Comments on current “timing measurement planes diagram” in 1722-2011
 Question: Is this diagram due for changes or replacement? (not sure.. Discuss..)

Figure <5.x> AVTP Listener's perspective when receiving media streams from multiple Talkers

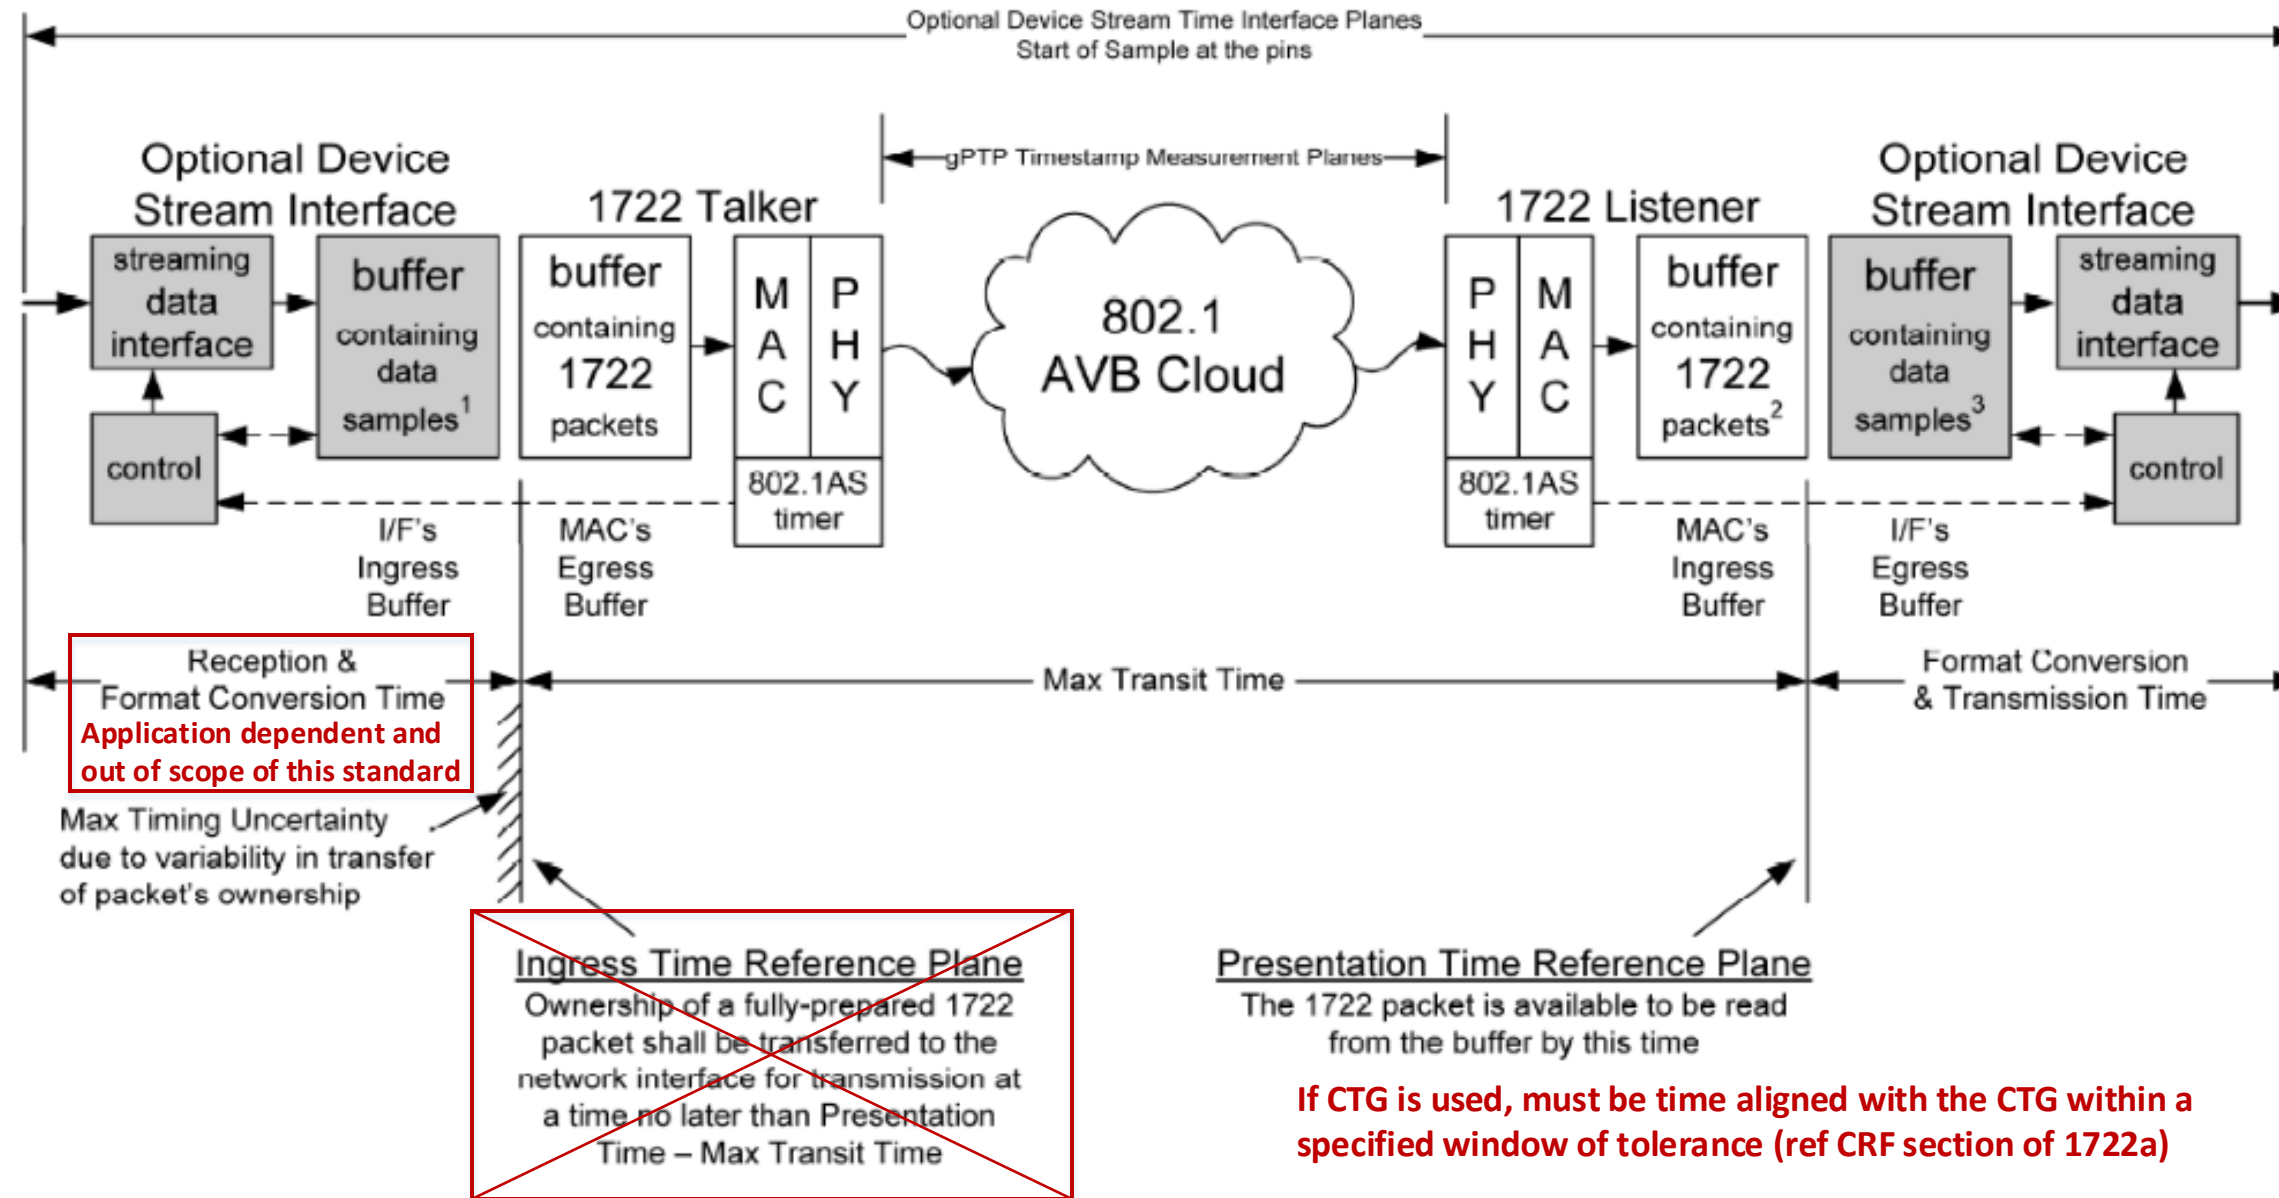
Possible new diagram to help more clearly define and quantify the “presentation time offset” concept and requirement

Example: Calculation of minimum Presentation Time Offset for Stream AC

$$PTO_{AC} \geq t_{GQ,A} + t_{MT,AC} + t_{QL,C}$$

- where:
- $t_{GQ,A}$ = time from sample generated to packet in tx queue for Talker A
 - $t_{MT,AC}$ = max transit time across network from Talker A to Listener C
 - $t_{QL,C}$ = time from rx queue to ready for app consumption for Listener C

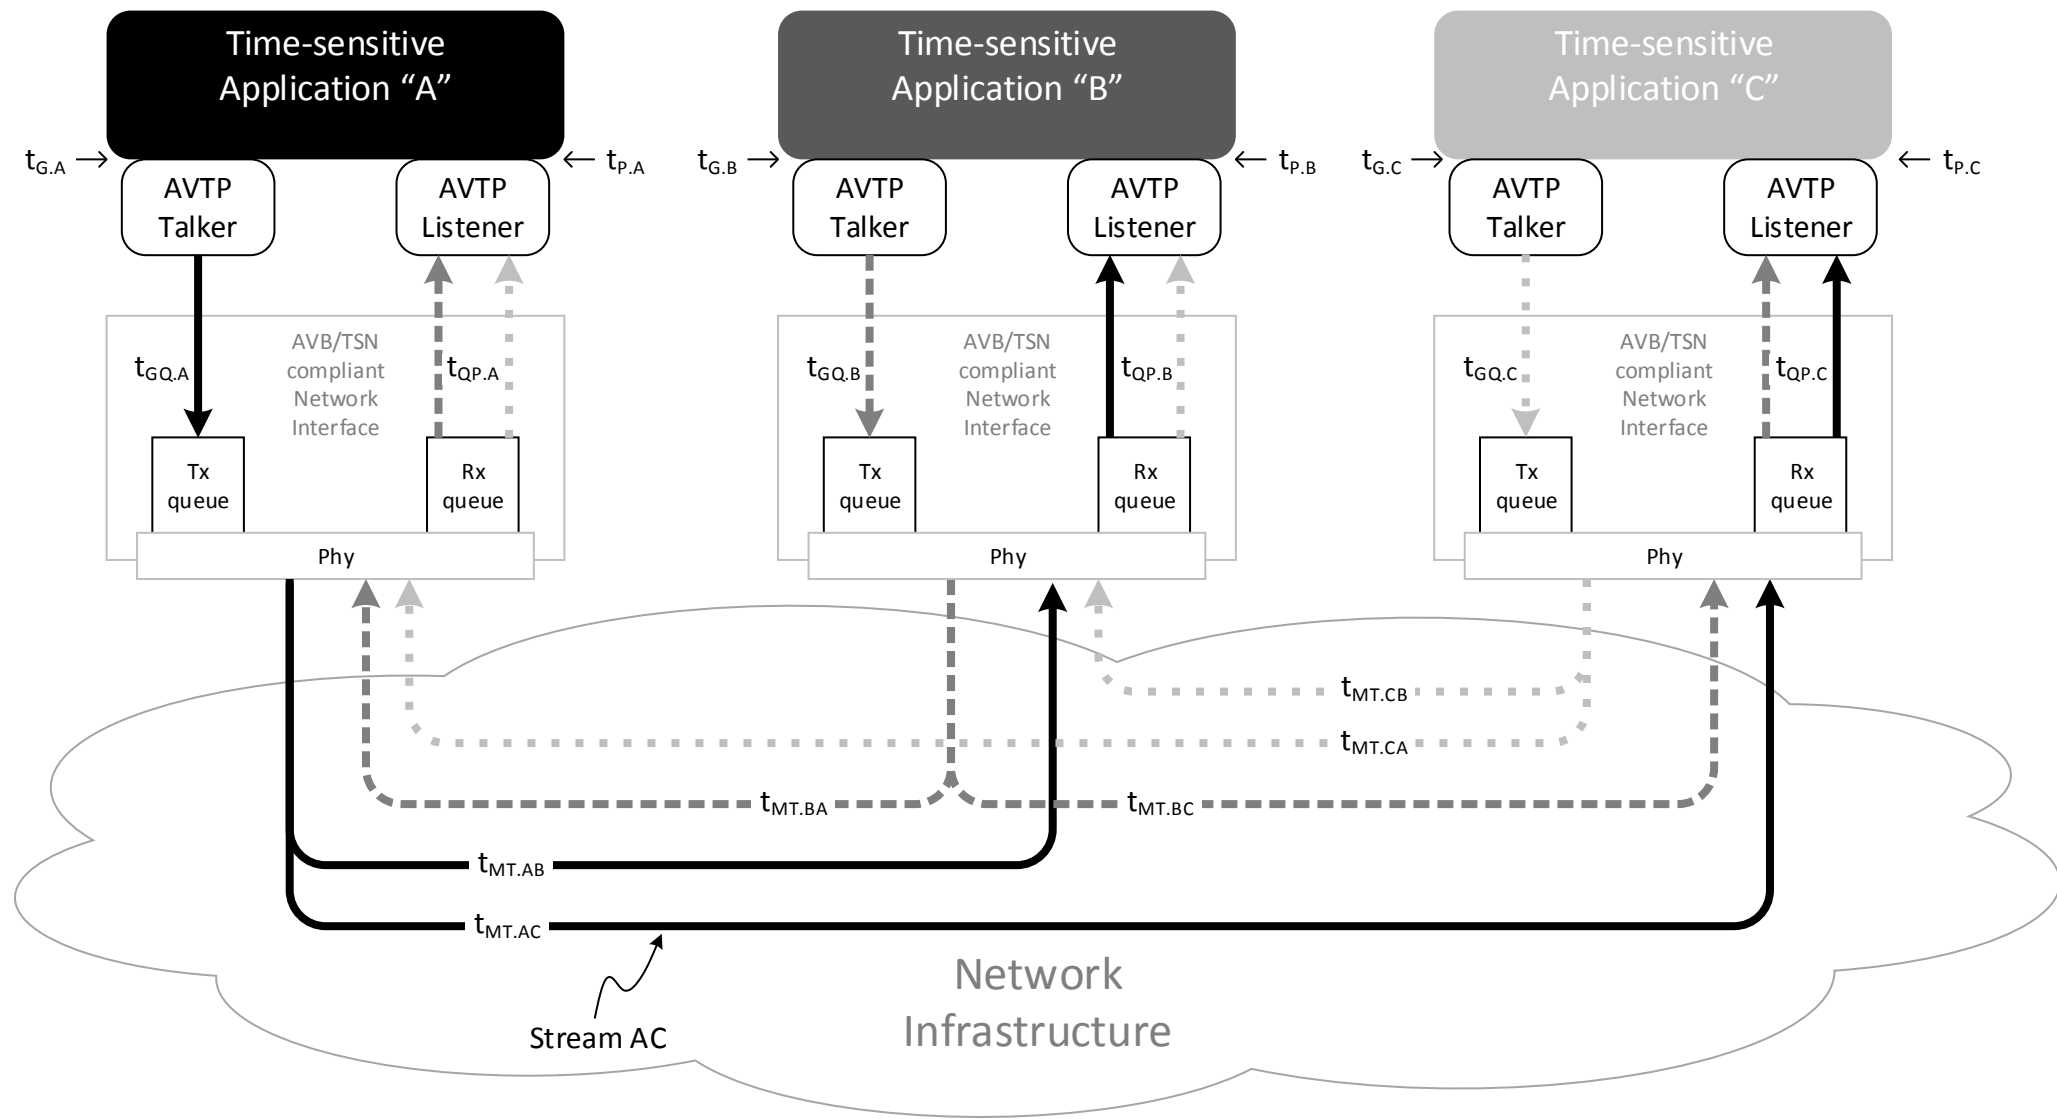
This implies specifics about implementation (i.e. how stream packets are generated prior to going on the wire) which arguably should be out of scope

Suggested Change

A Talker shall queue each 1722 stream packet for transmission at a time no later than $(PT - MTT)$, where PT is the presentation time in the current packet and MTT is the Max Transit Time.
